RE: System Installation Inspection  
Seiford Property 19 Elf Hill Road

## APPLICATION FOR DISPOSAL SYSTEM CONSTRUCTION PERMIT

SEPTIC SYSTEM REPAIR PLAN FOR BEVERLY SEIFORD		
SCALE: NOTED	APPROVED BY: AW	DRAWN BY: AW
DATE: 12/26/00		REVISED
<b>19 ELF HILL ROAD AMHERST</b>		
COLD SPRING ENV, INC.		DRAWING NUMBER: 100-1238-1011

SUBSURFACE SEWAGE DISPOSAL SYSTEM INSPECTION FORM  
PART A  
CERTIFICATION

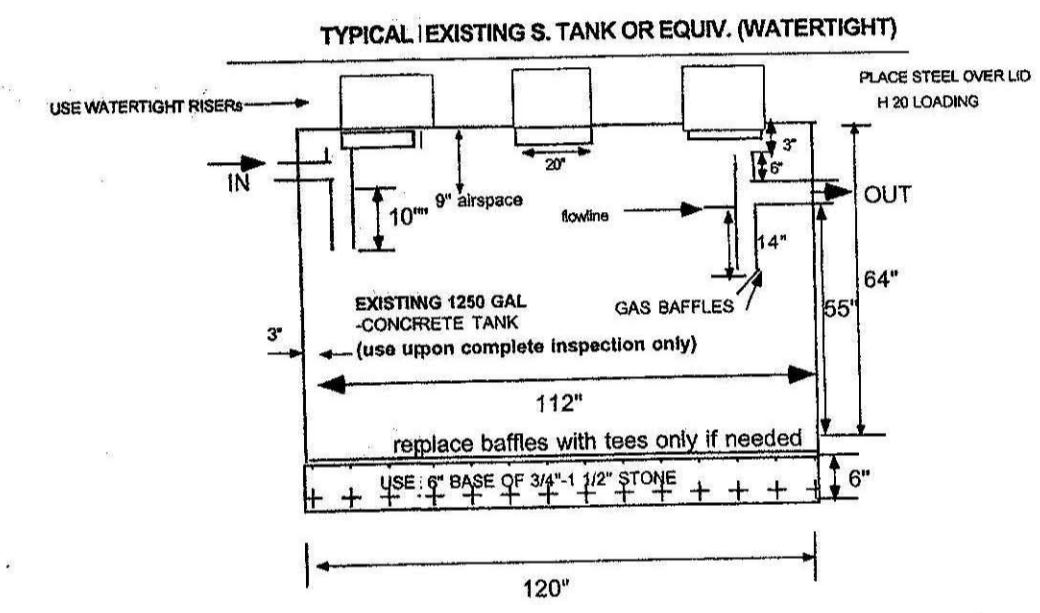
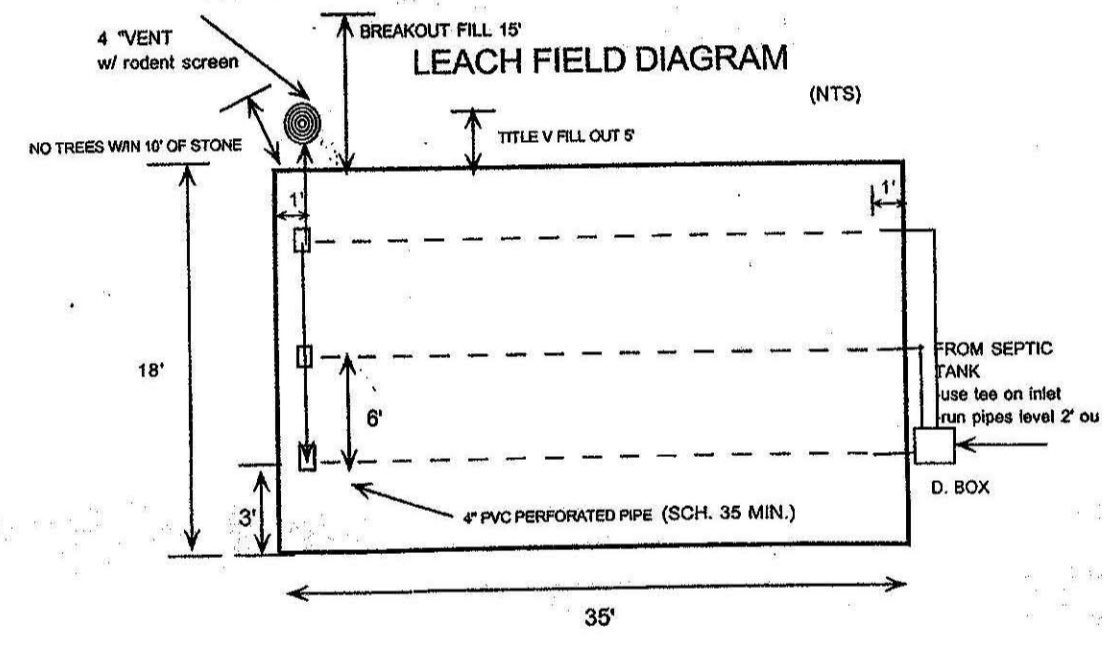
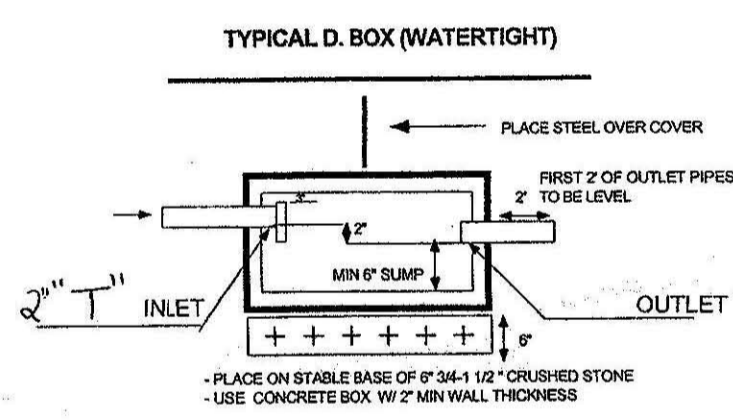
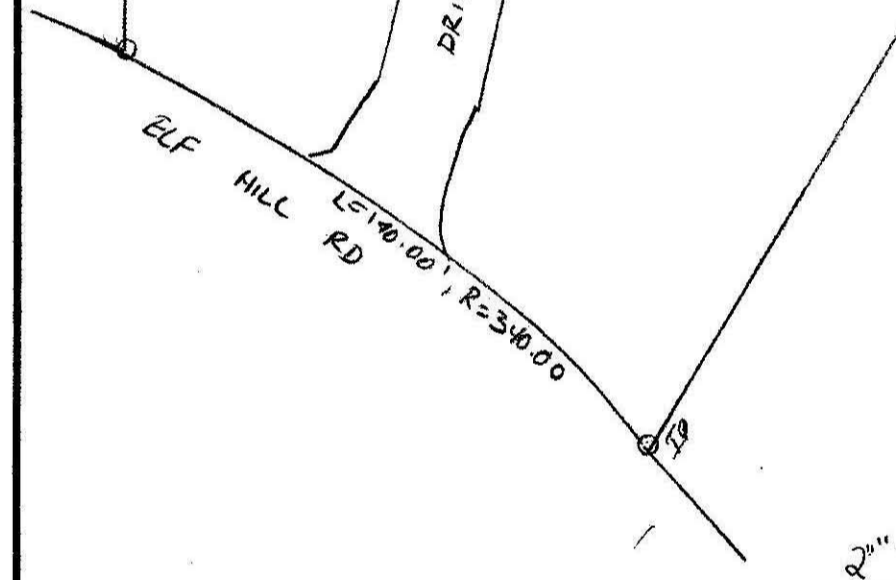
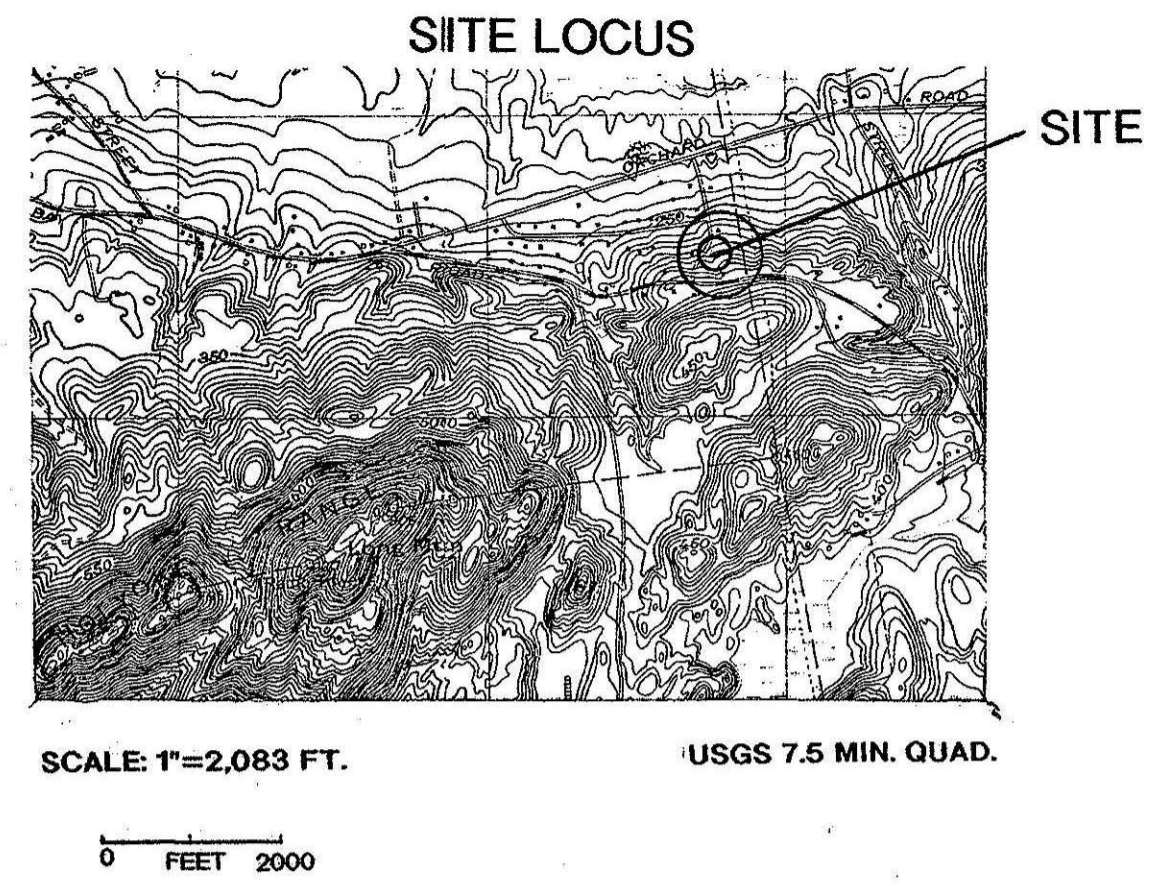
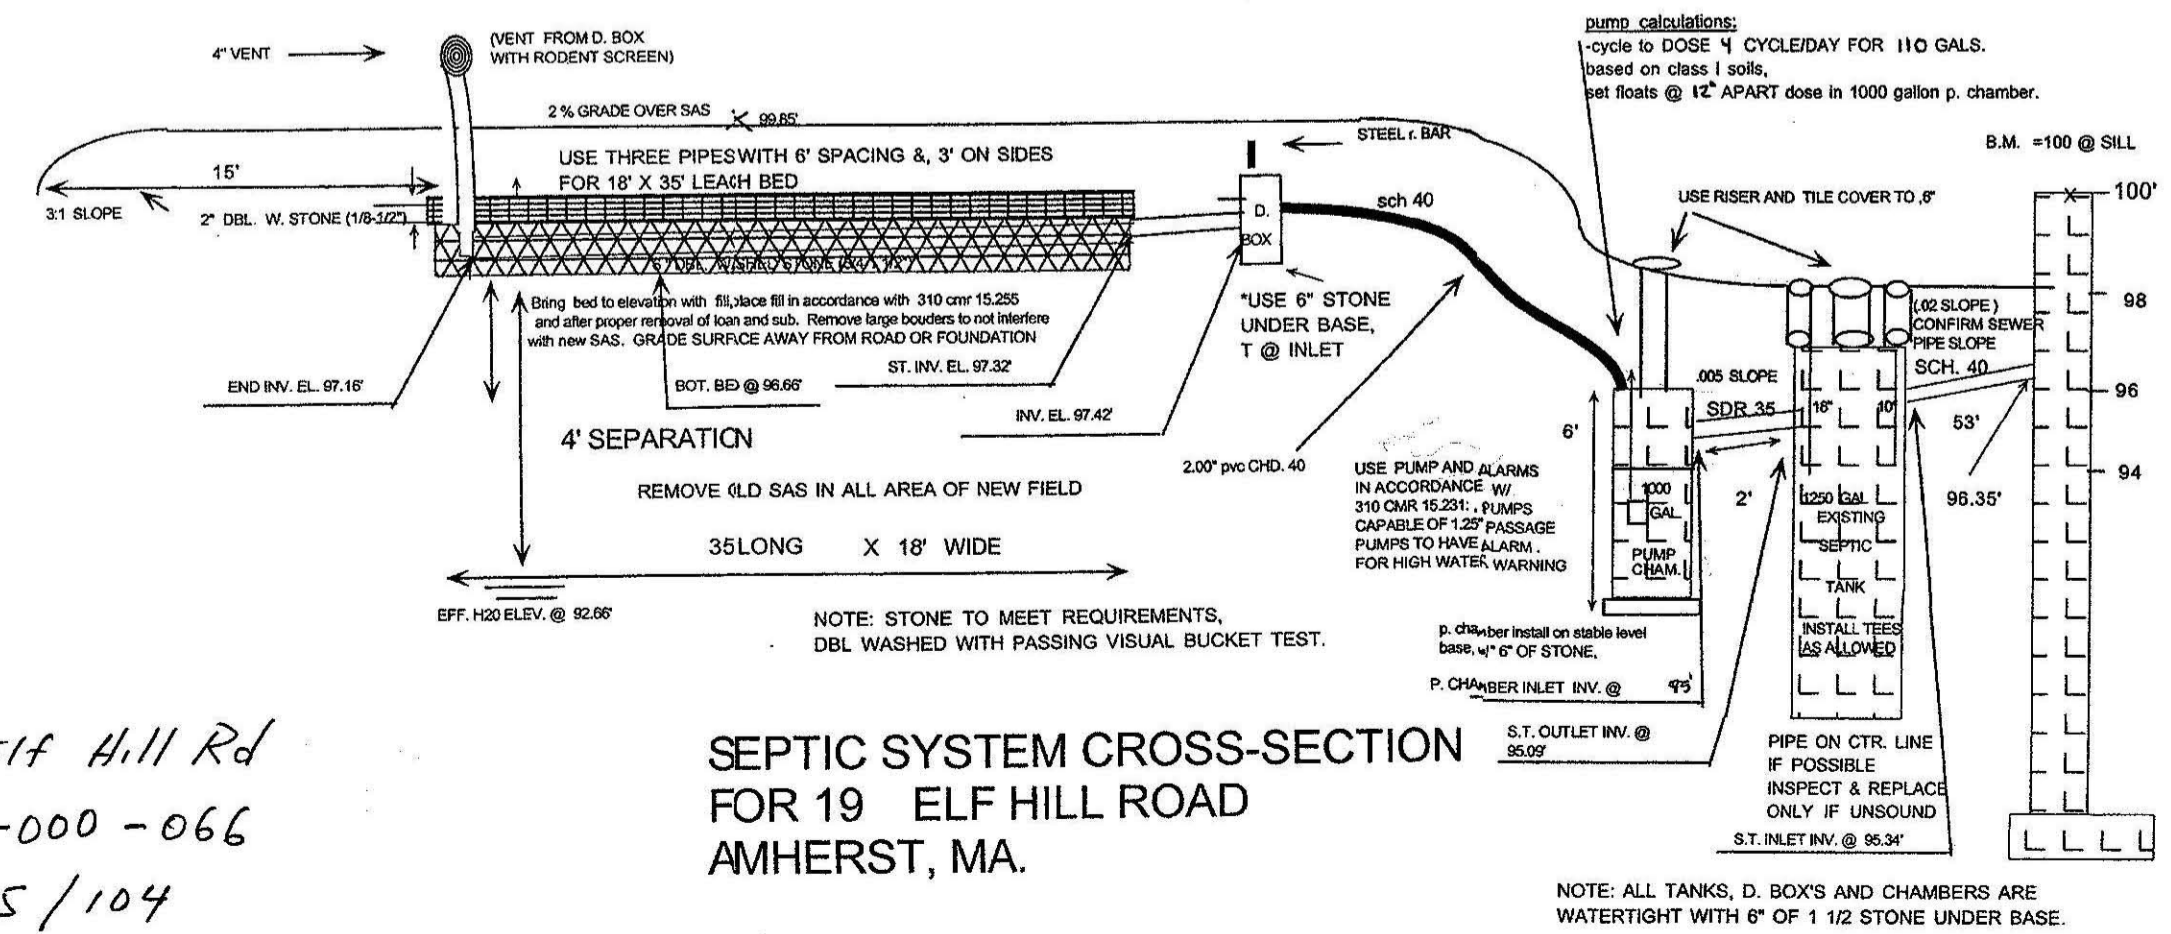
SANITARIAN TO VERIFY: (AL)

- ① Water Line
- ② SEPTIC TANK TO MEET Code
- ③ REMOVE ALL OLD SYSTEM IN FAVOR New System

**SKETCH OF SEWAGE DISPOSAL SYSTEM:**

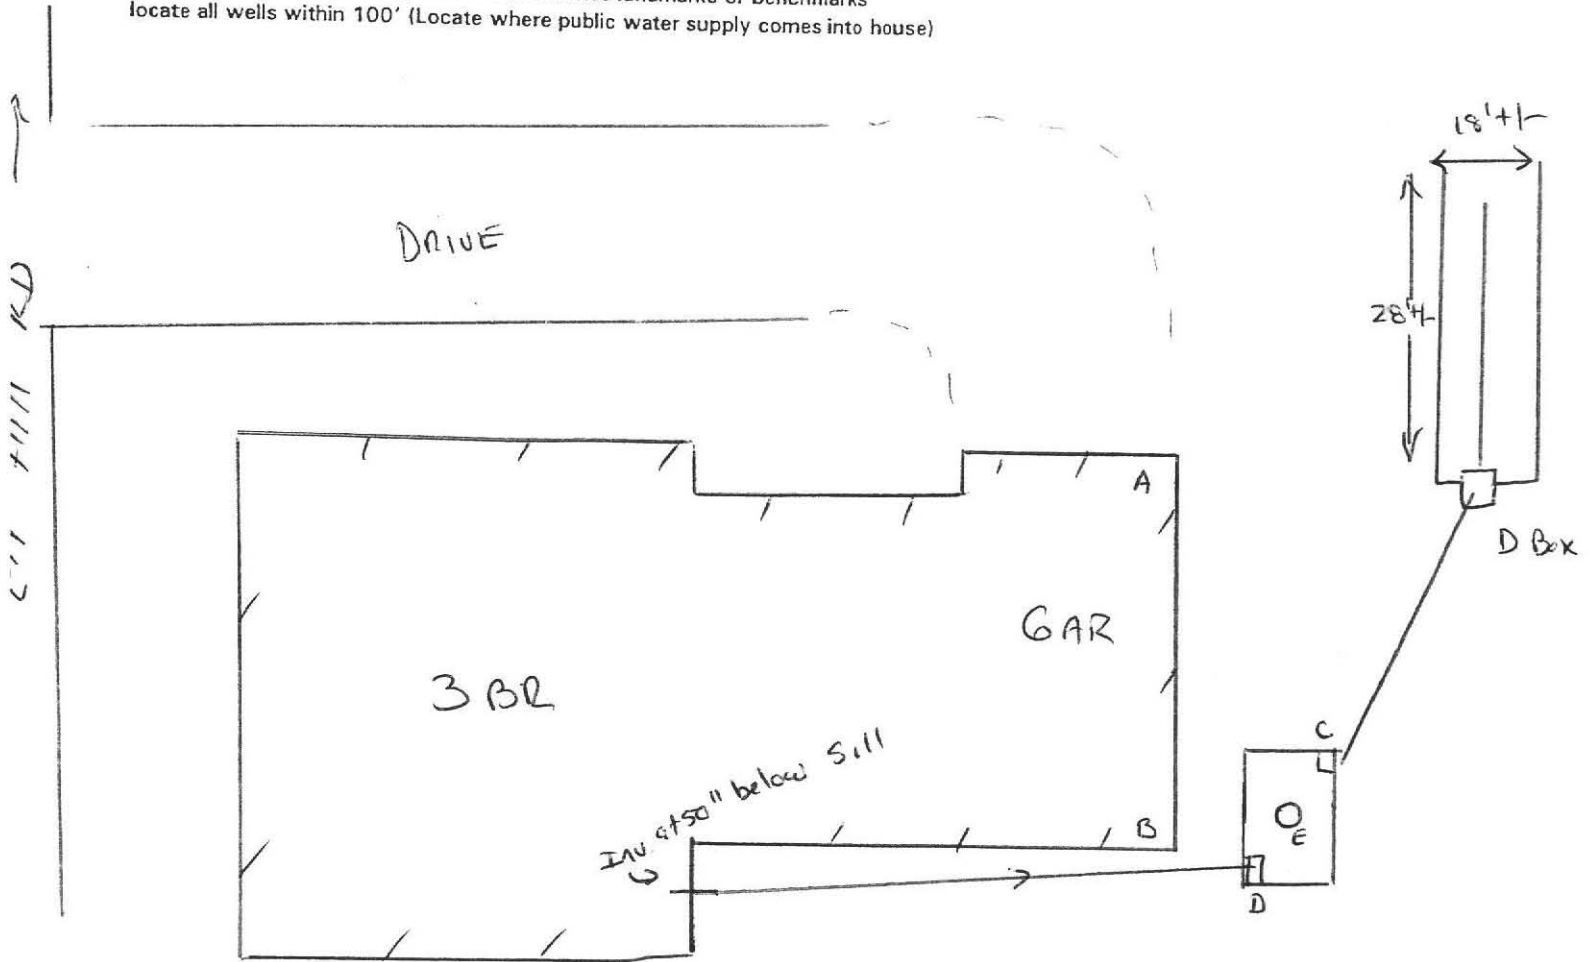
Comments:  
(note if level and distribution is equal, evidence of solids carryover, evidence of leakage into or out of box, etc.)  
Sides + Top Corroded + broken; Full of Sludge. (carryover)

Failure at D box. Full of liquid + sludge, stone block + saturated.
